***IEEE P802.3dg
Downshift/Upshift
Proposal & Draft Text***

Peter Jones, Cisco Systems

August 2025

Figure 1 Downshift state diagram

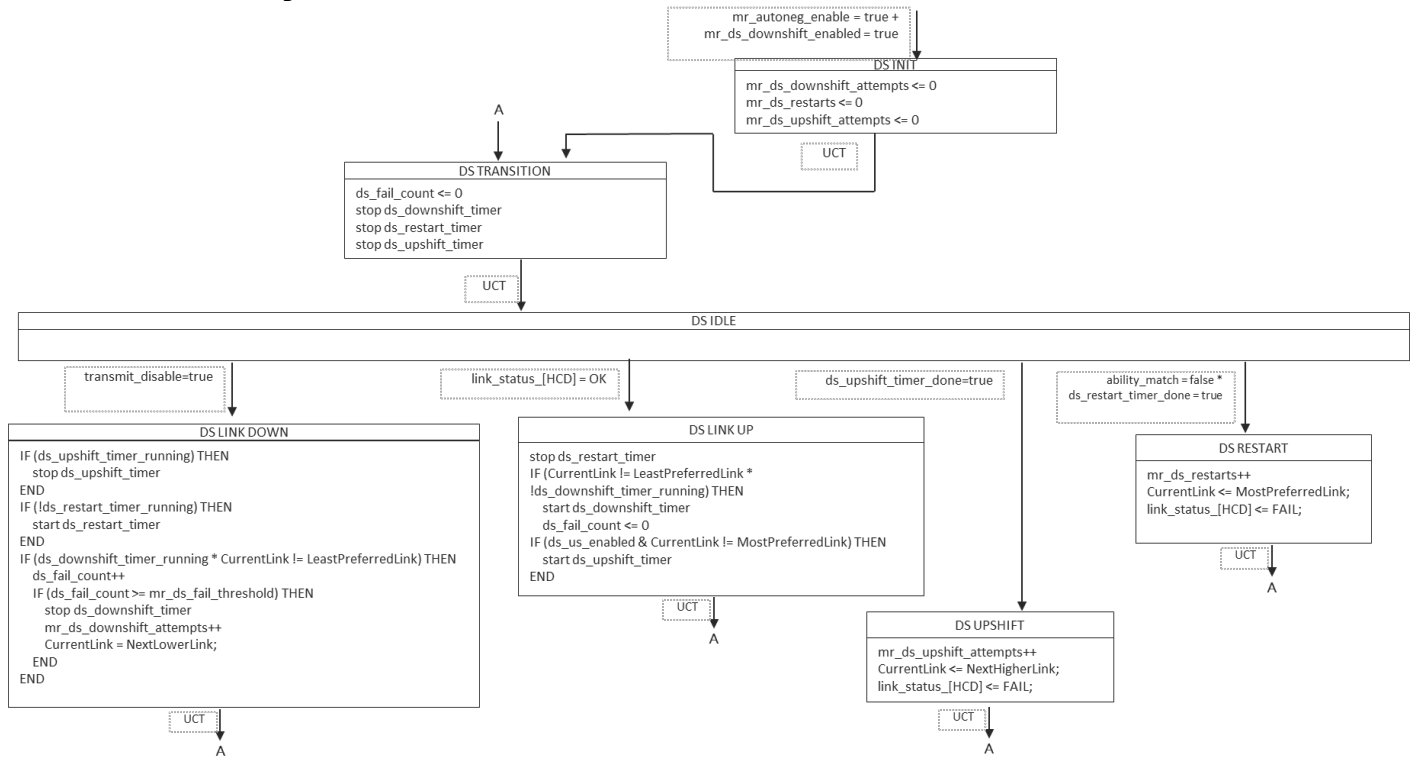
There is a strong preference not to change the current Clause 98 Arbitration state diagram. A new annex will be specified with a state diagram (with variables, functions, etc) running “in parallel” with the current Figure 98–7—Arbitration state diagram state diagram.

98D.2.6 State diagram
